MEMO

From: Lynn Schmidt, PE, CFM, Statewide Flood Engineer, Ecology SEA Program

Subject: Stream Channel Migration and the Clallam County SMP Update – Release of final documents and response to County questions

Example 8: Lyre River – Near the mouth - Map 46 of the Puget Sound Streams (WRIAs 18 – 19) report.

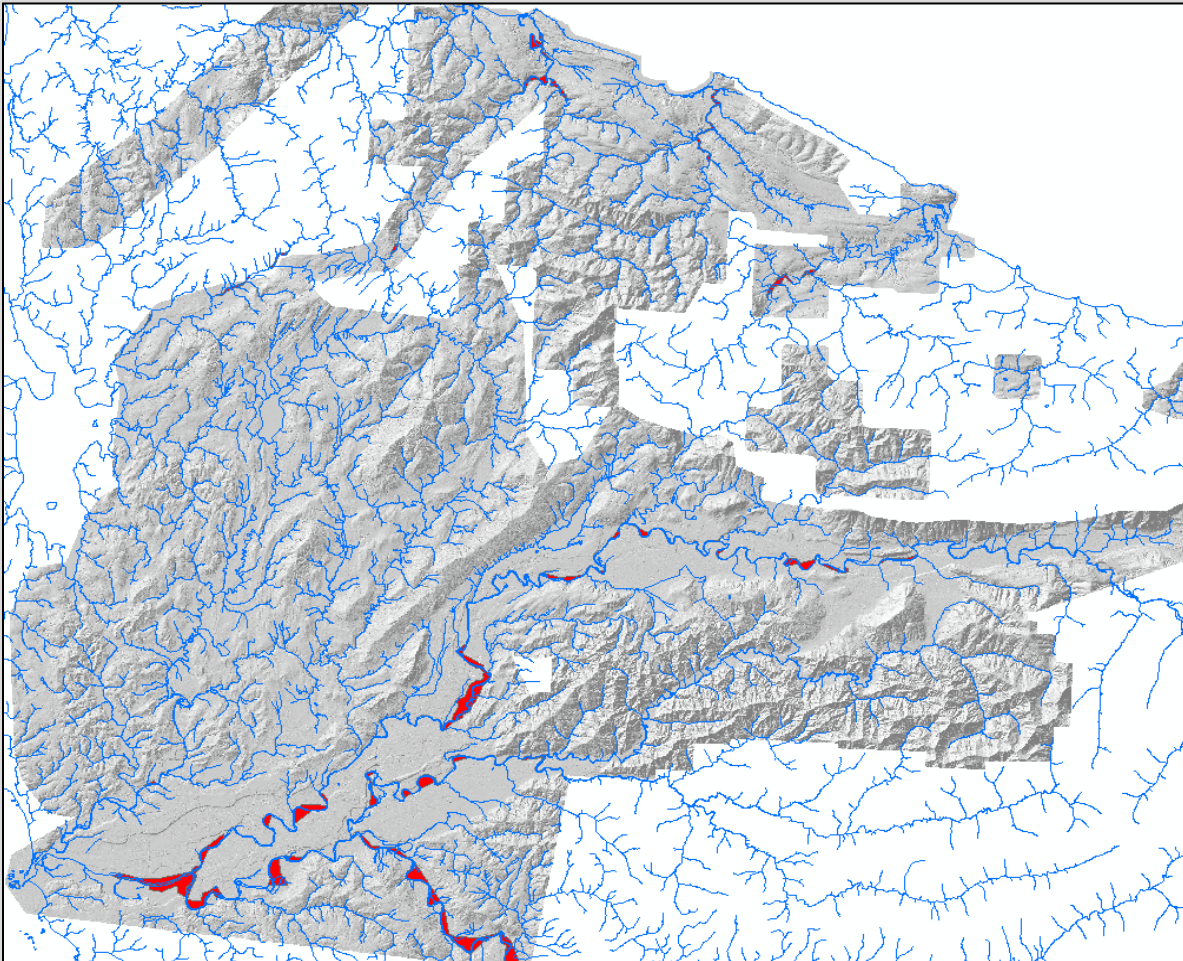
The CMZ area near the mouth of the Lyre River is characterized by state and conservation lands on the east-side and rural residential lands on the west-side. On the west side of the river, most of the rural residential lots between the river and W. Lyre River Road (north of intersection with Harrison Beach Rd) are fully or substantially within the mapped CMZ. Landowners in this lower river reach have questioned the width of the CMZ. The homes are setback generally more than 100 feet from the river and based on LIDAR on terraces 10+ feet above the river. There is no evidence of any significant channel movement on aerial photos in at least the last 20+ years. What is the basis of the outer extent of the CMZ on the west side of the river in the developed areas near the mouth? How much of this is based on the erosion hazard buffer calculation?

Ecology Response: In the Pacific Streams (WRIA 20) report, Chapter 4.4. (4) describes delineation of areas of potential channel migration, including Underfit Streams (page 33), and Figure 4.7 and related text (pages 34-35) addresses the issue of stream valleys formed by glacial processes such as scouring and outwash.

In addition, the Lyre River is specifically explained in Chapter 4.4 (7) on page 38-39:

"The Lyre River example of valley expansion (Figure 4.6) was observed in many streams evaluated by this study. Many included obvious examples of shallow or deep-seated landslides, both recent and prehistoric that had occurred along stream valleys. The potential channel migration boundary in reaches where evidence of valley widening is occurring includes the entire valley bottom plus a portion of the valley wall. The streamlined pCMZ delineations were not intended to be precise, but rather meant simply to call out areas where a more detailed assessment, including a geotechnical analysis, is needed to determine the geographic extent of the hazard. The area where a geotechnical setback buffer is needed is indicated on the maps with black dots in the CMZ boundary line."
